# UNITED STATES PATENT AND TRADEMARK OFFICE

APPLICATION NO.	FILING DATE	FIRST NAMED INVENTOR	ATTORNEY DOCKET NO.	CONFIRMATION NO.
10/816,585	03/31/2004	William H. Whitted	GOOGP022	8421

**Office Action Summary**

## DETAILED ACTION

**Fig 1**

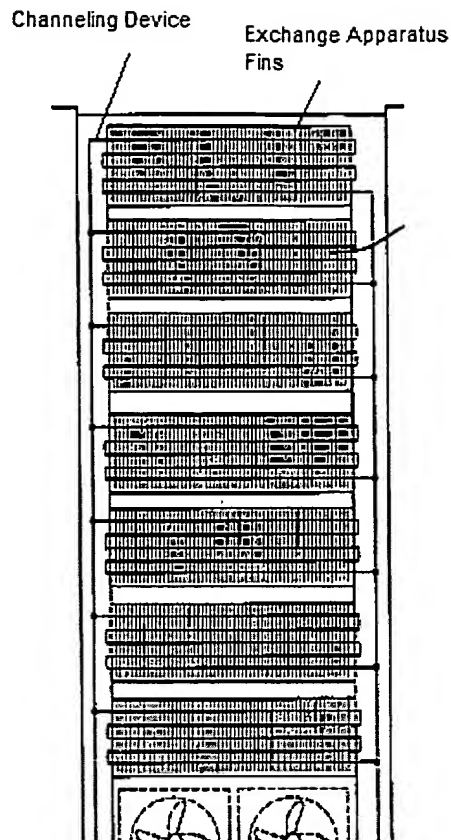
With respect to claim 8, Chu et al. further teaches that each heat exchanger includes a heat exchange fluid channeling device and a heat exchange apparatus in thermal communication with the heat exchange fluid channeling device (See present office action Fig 1 below).

With respect to claim 19, Chu 770 further teaches that the means for cooling air (21) includes a means (As illustrated in the present office action Fig 1 above) for channeling a heat exchange fluid and means (Fins as illustrated in POA Fig 1 above) for channeling the heat exchange fluid extends.

With respect to claim 20, Chu 770 further teaches that the means for heat exchange includes a plurality of heat exchange fins through which the means for channeling the heat exchange fluid extends (As illustrated in POA Fig 1 above).
